May 19, 1988

PLANT VOGTLE - UNIT 1  
NRC DOCKET 50-424  
OPERATING LICENSE NPF-68  
REQUEST TO REVISE TECHNICAL SPECIFICATION 3/4.7.6  
CONTROL ROOM EMERGENCY FILTRATION SYSTEM

PLANT VOGTLE - UNIT 1  
NRC DOCKET 50-424  
OPERATING LICENSE NPF-68  
REQUEST TO REVISE TECHNICAL SPECIFICATION 3/4.7.6  
BASIS FOR PROPOSED CHANGES

FIGURE 1

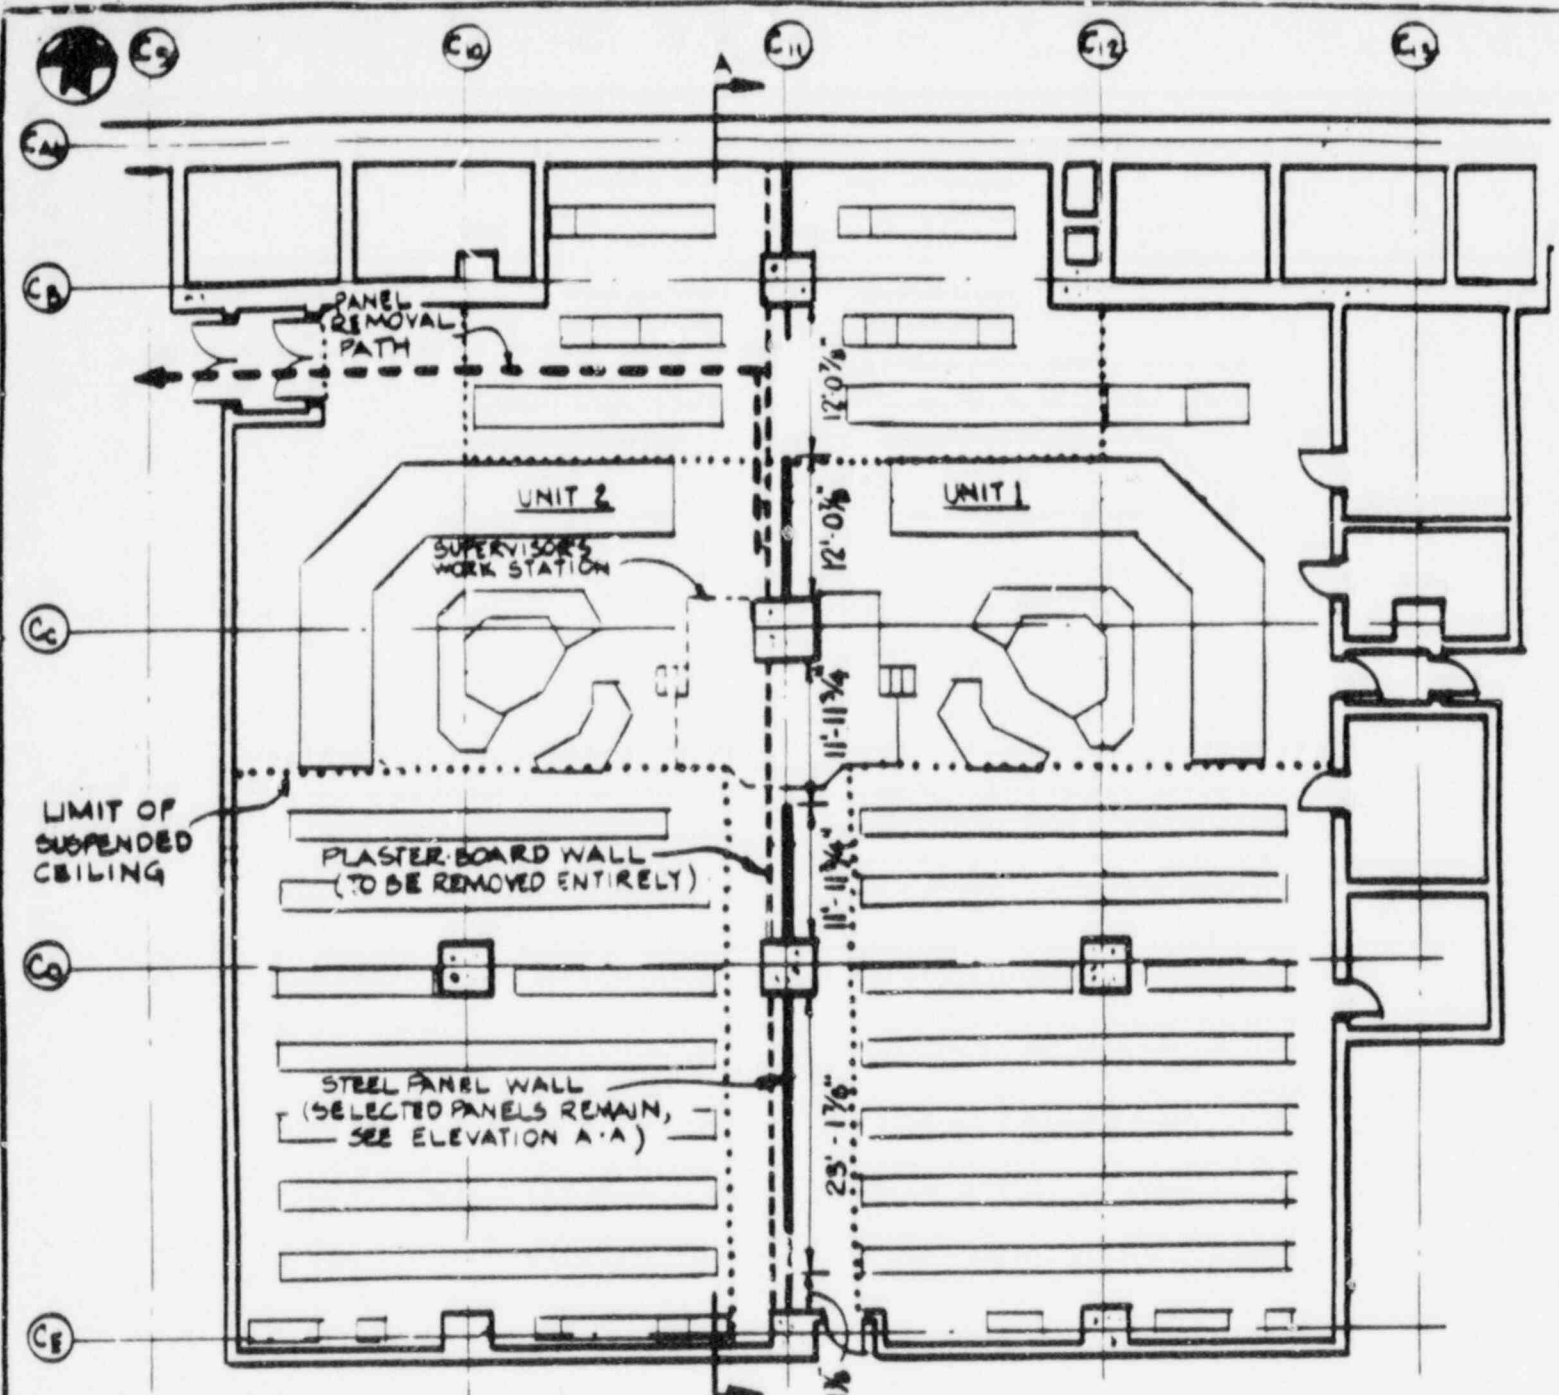
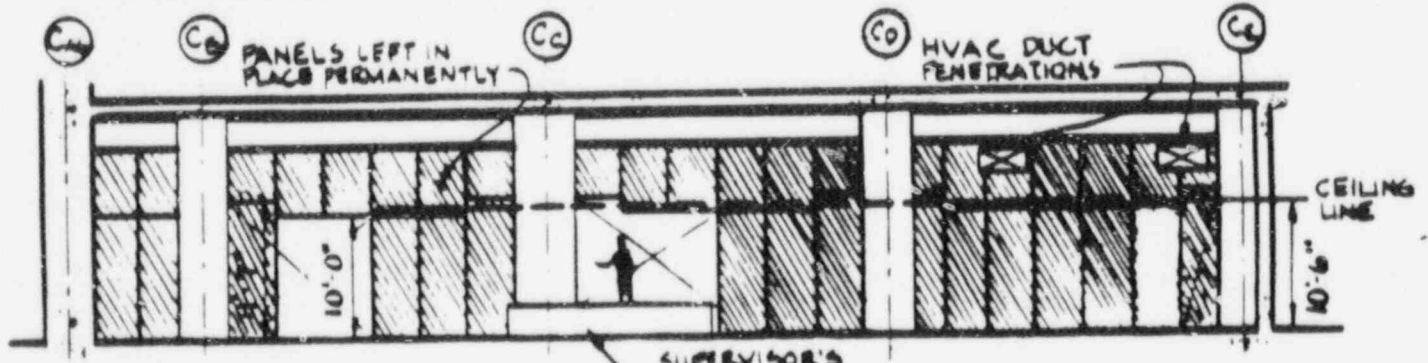
Area is extended to include the Unit 2 portion of the control room, GPC proposes to remove portions of the temporary wall prior to the scheduled Unit 1 refueling outage. A plan has been developed for wall removal with a minimum of disruption to Unit 1 operation. This plan includes the following activities:

1. Preparation
  - a. Panels to be removed will be marked on both sides.
  - b. A metal frame work enclosure with 2 inches of styrofoam for noise control and an "A" cloth curtain will be installed on the Unit 1 side of the barrier prior to wire brushing, cutting, or grinding. The enclosure will minimize visual distraction, noise, and fumes while work is in progress.

- b. Cut panel sections will be removed through the Unit 2 side of the control room.
  - c. Grinding and other noisy activities will be minimized.
  - d. Panels will be removed as quickly as possible. Figure 1 shows the panels to be removed.

FIGURE 2

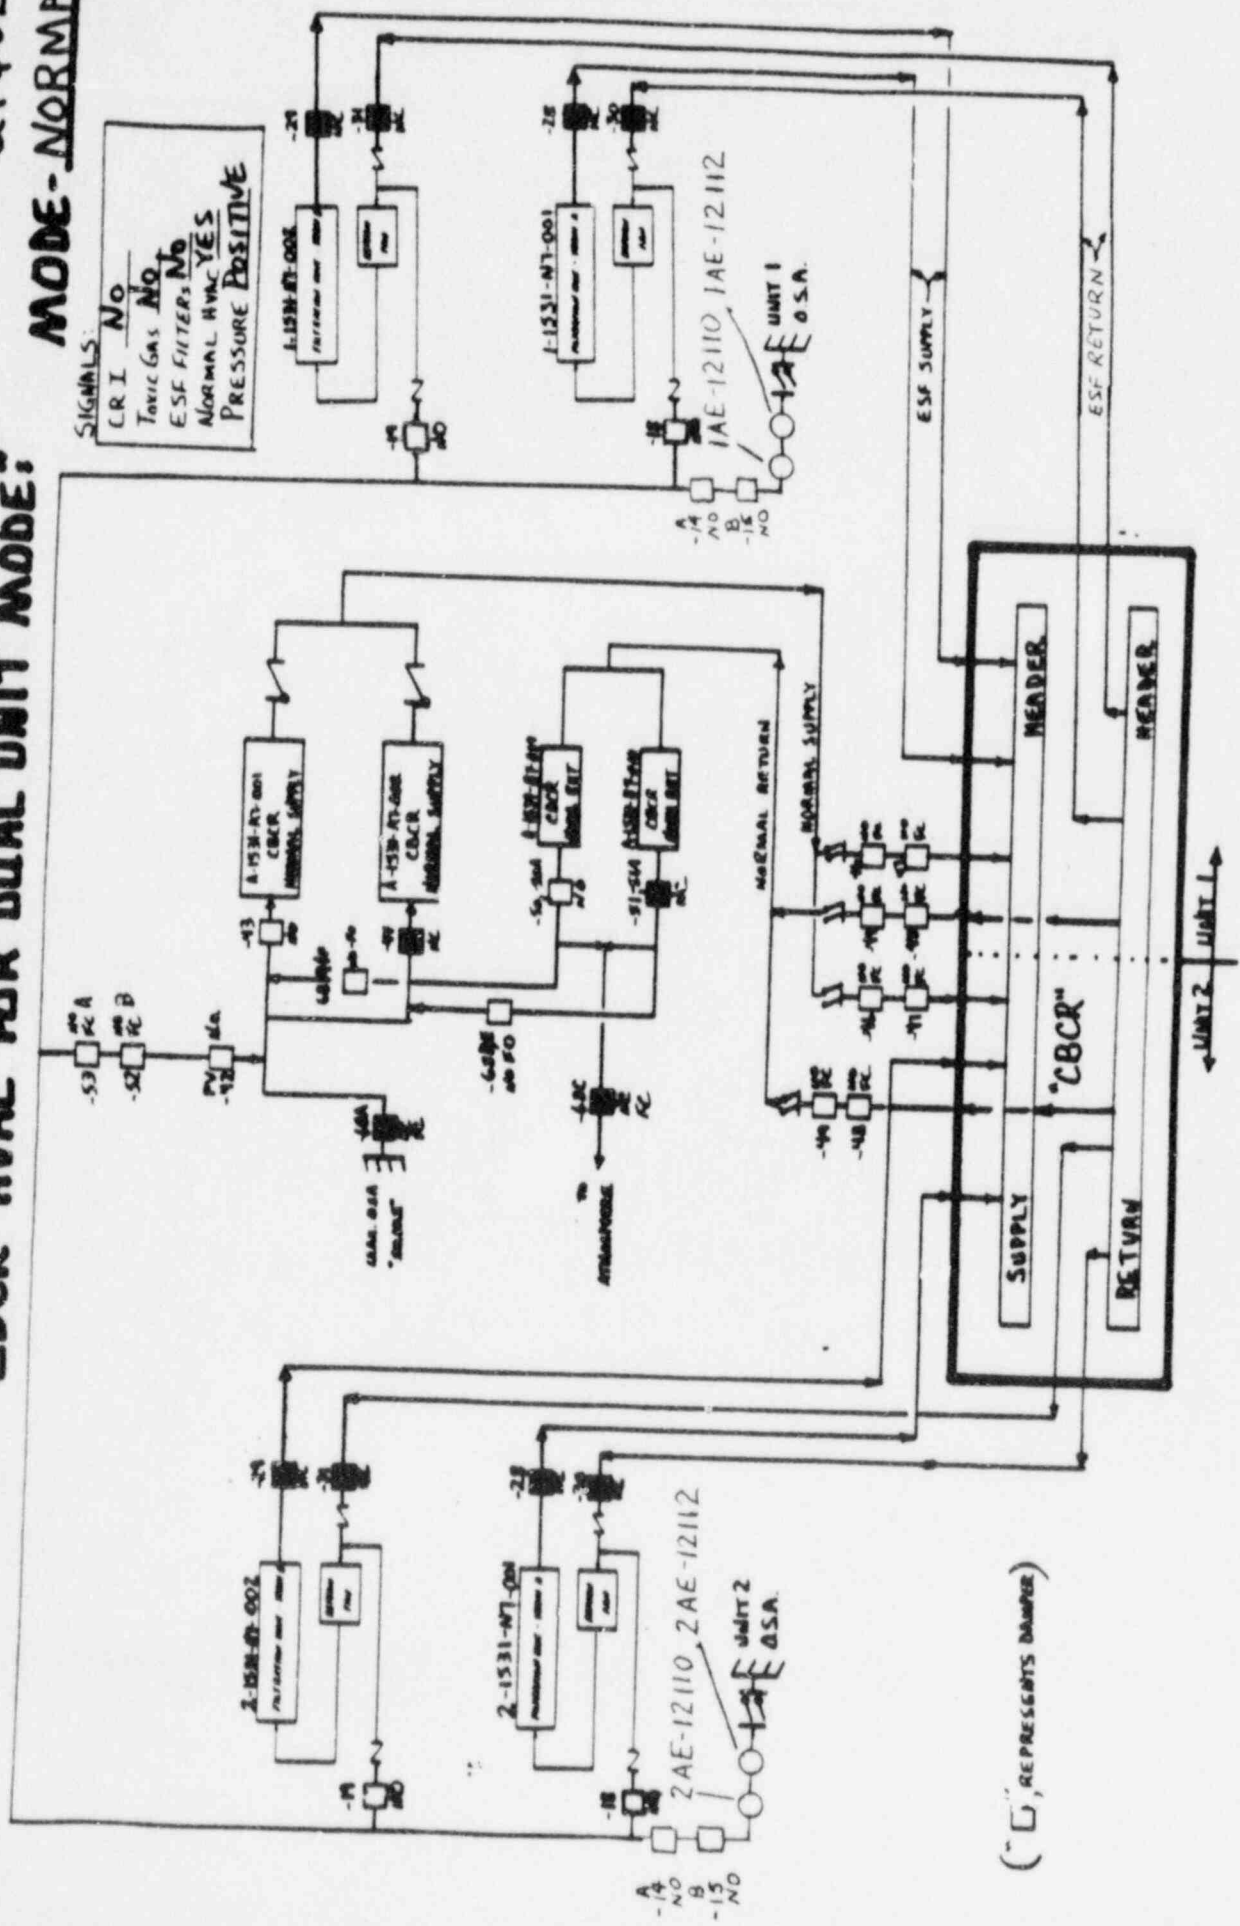
HVAC system balancing to support wall removal has been planned to provide the maximum assurance of CREFS operability during each step of the process. The control room HVAC systems are shown schematically in Figure 2. The control room supply and return headers are presently separated as shown in Figure 3. HVAC balancing will be performed in the following steps:

The activities discussed in Proposed Change 1 will result in a two-unit control room with two air intakes supplying outside air to the common control room. The normal HVAC outside air intake flowrate will remain 3000 cfm as previously evaluated irrespective of whether Unit 1, Unit 2, or both flowpaths are being used. Each outside air flowpath must have instrumentation capable of initiating protective action for a chlorine or radiation release. In addition, each ESFAS train in each unit must be capable of initiating CREFS to provide radiation protection on a Safety Injection (SI) signal. One CREFS train will provide radiation protection and heat removal for the combined control room.

FIGURE 3

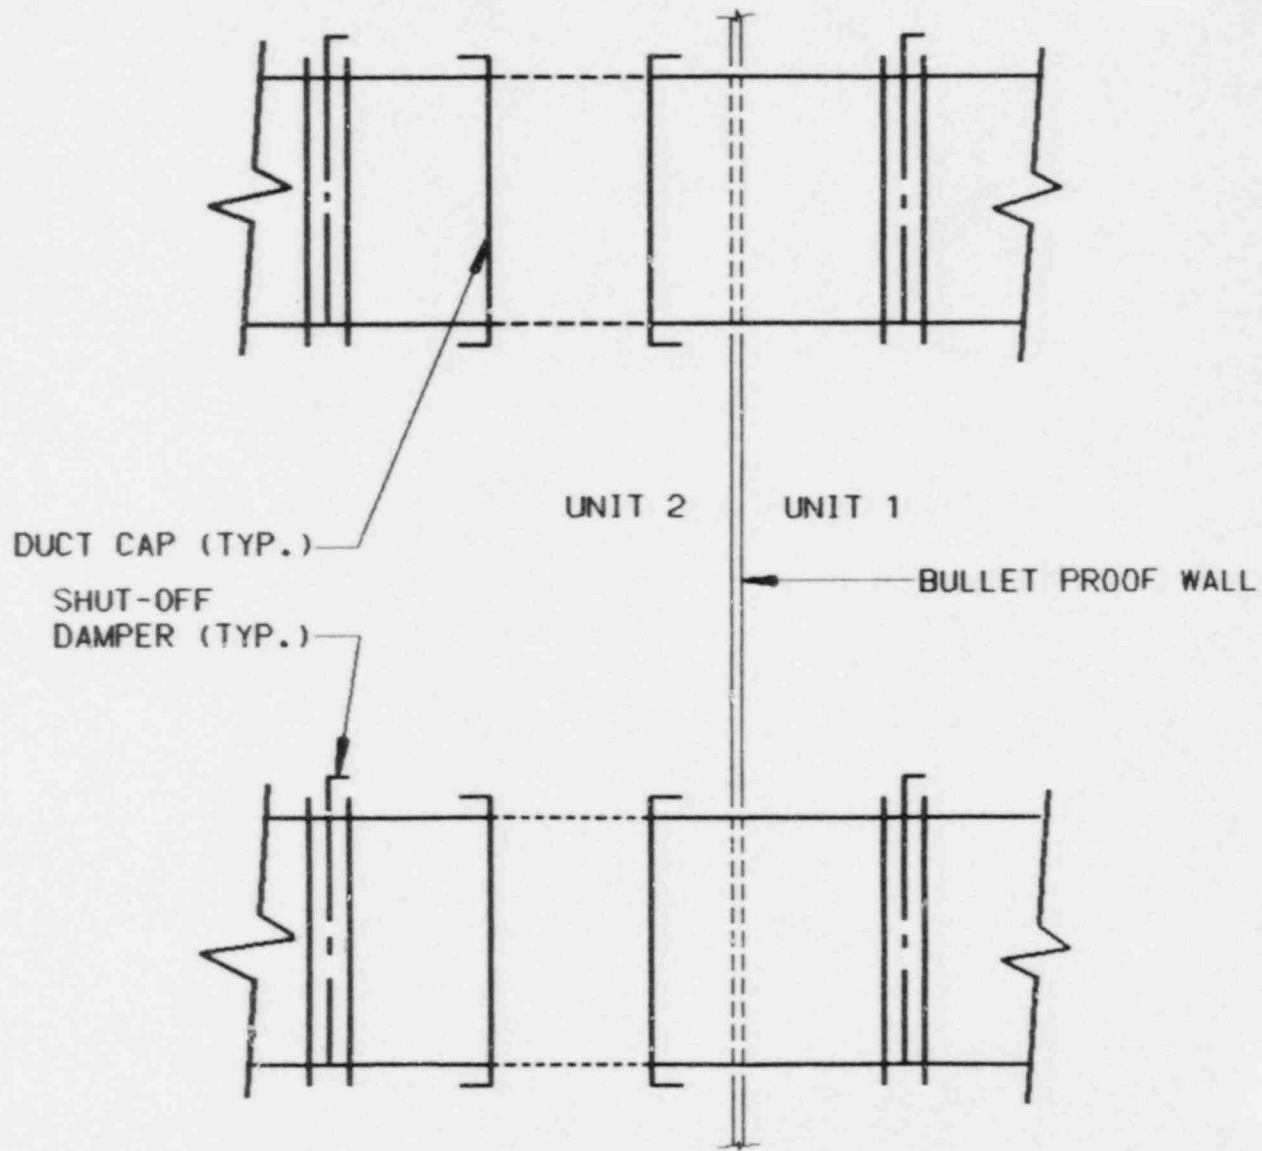
2. Adjust the Unit 2 outside air dampers to approximately 1300 cfm and measure the resulting control room pressure on the Unit 2 side.
3. Measure the leakage rate of isolation dampers 1-1531-D7-100 and 101 and 2-1531-D7-100 and 101 which are shown in Figure 3. Verify that total leakage is less than 70 scfm.

4. Remove the duct caps and install the spool pieces, leaving the dampers closed.
5. Balance the Unit 2 CREFS for dual unit operation with 1500 cfm outside air and 19,000 cfm  $\pm 10\%$  recirculation.

Measurement of leakage through the Unit 1/Unit 2 isolation dampers (Step 3) will be performed by reducing the pressure in the space between the damper and the duct cap to below atmospheric. Leakage will be measured to verify that the total does not exceed 70 scfm. This step is necessary to assure the capability to isolate the Unit 1 portion of the control room and restore the HVAC boundary. The isolation dampers will
